Date of Notice: (DD/MM/YYYY) **12/07/2022** Product Change Notice Number: **USB1046 B4 PCN 20220712**

Product Identifier: **USB1046-GF-XXXX-L-B-X**

Drawing Revision Letter: **B4** Effective from date code/batch code: **220706 onwards**

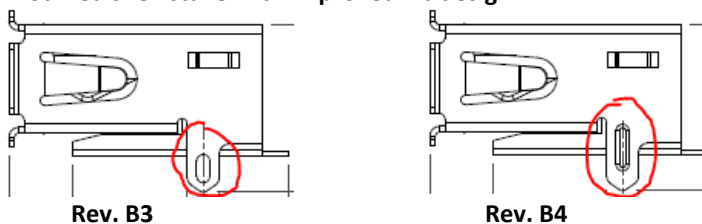
1. Modified insulator with chamfer

2. Modified shell stake with improved rib design

- 1. Adding the chamfer improves insulator strength**
- 2. Improved rib design helps insertion prior to soldering**
- 3. GCT's continued commitment to reduce waste by deploying a more efficient packing method**
